Zoning Staff Report

Case Number: ZC-21-131

Zoning Map Amendment

Site Location: 8661 & 8689 John T. White Road

SHEET TITLE:
SITE PLAN FOR R2 ZONING
 A TOWNHOUSE DEVELOPMENT
 JOHN T. WHITE BOULEVARD AT RANDOL MILL ROAD
 FORT WORTH, TEXAS

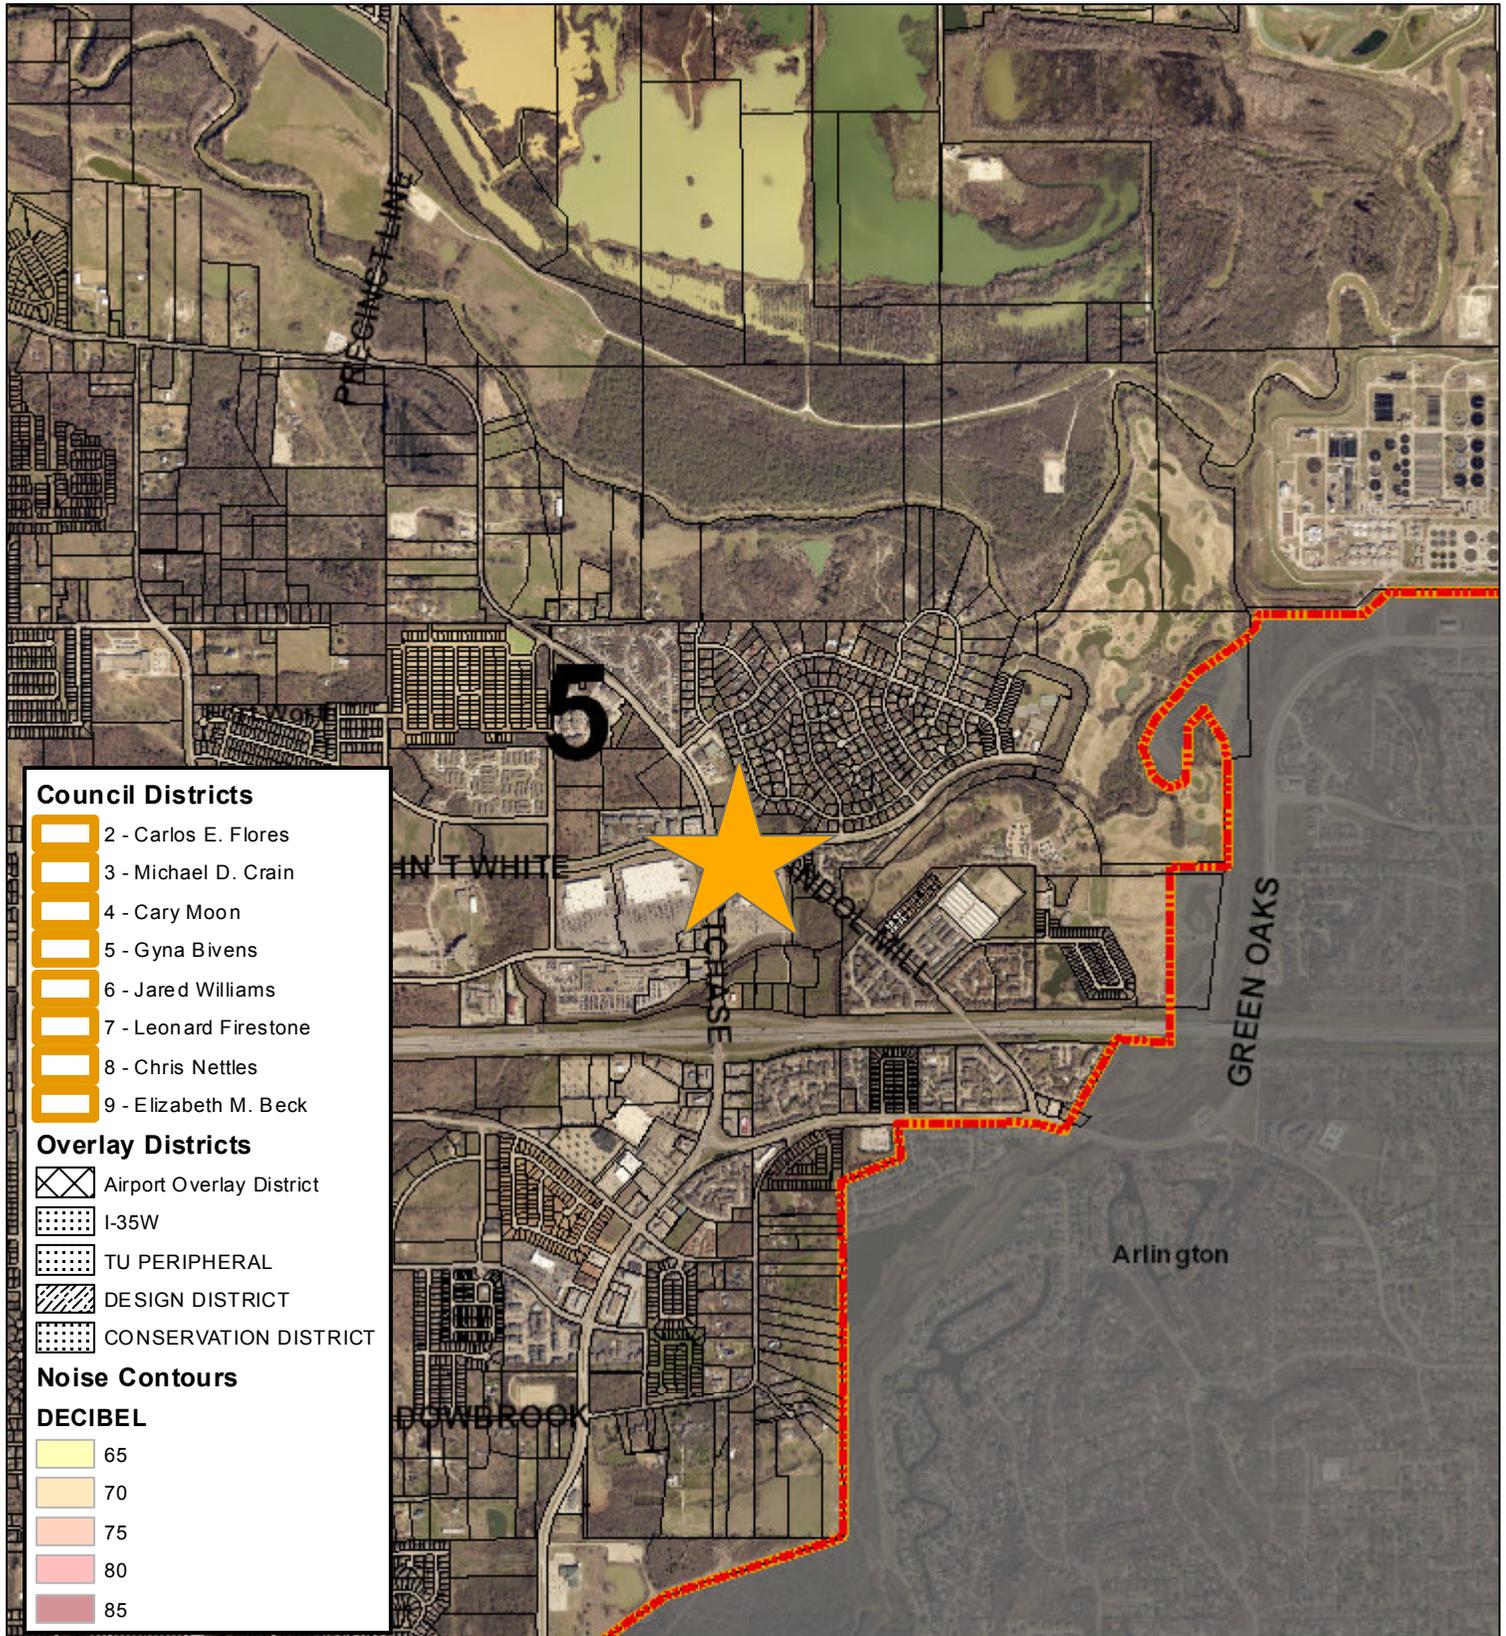
- Please add the following to the site plan:
 - o A date and signature line for “Director of Development Services” in the lower righthand corner, as well as the zoning case number (ZC-21-131).

- o Zoning of surrounding properties (“A-5” One-Family for residential lots to the north and east, “E” Neighborhood Commercial for subject property and site to the north)

- o The legal description for this site.
 - o The following general notes:
 - This project will comply with Section 6.301, Landscaping.
 - This project will comply with Section 6.302, Urban Forestry.

- All signage will conform to Article 4, Signs.
 - All provided lighting will conform to the Lighting Code.
- Please label the following:
 - o Height and material of the existing fencing at the eastern edge of the property.

- o Pavement type for driveways and internal alleys.
 - o Proposed site density (units per acre).
- The location and dimension of all proposed structures should be depicted on the site plan. Please indicate where the townhome buildings and associated parking areas will be located and label total square footage and building height.

- A parking analysis is required. The minimum parking requirement is two spaces per dwelling unit, located behind the front build wall. Please label minimum required and total provided spaces.

- The proposed open space areas do not appear to meet the intent of the Zoning Ordinance as they are separated from the residential properties by masonry walls. Please indicate how these areas will be utilized by the residents of this development. A waiver will be required for the current design.

- FYI – an encroachment agreement may be needed for the portions of the masonry wall that are proposed within the utility easements along the property boundaries.

- Provide information on the proposed townhomes. If sold as individual fee simple lots, a preliminary plat is required.
- Subdivision Ordinance, Section 31-106(g) Alley design standards.
 - (1) Length. Alleys shall be of a similar length as their associated opposite and parallel primary service streets, except for any additional length required for turnout returns to the primary service street. Dead-end alleys are prohibited. An alley with only one outlet shall be provided with an approved turn-around.
- The proposed multifamily development is proposed over two separate platted lots (Bentley Village Addition, Block MR, Lot 2, Lot 3). A final short plat (replat) is recommended to avoid any potential conflict with provisions of the Subdivision Ordinance standards (i.e. utilities crossing over property lines, access management drive way spacing).

- Access to all proposed lots is subject to the Fort Worth Access Management Policy. A waiver to the access management policy is required for the proposed access onto John T. White and Randol Mill road.
- Single-family and two-family residential alley width is 16ft. with 12 ft. paving edge to edge. Deadened alleys require a waiver from the planning commission.

- On Commercial Connector right-of-way driveway spacing is 250 feet and 200 feet on Neighborhood connectors.
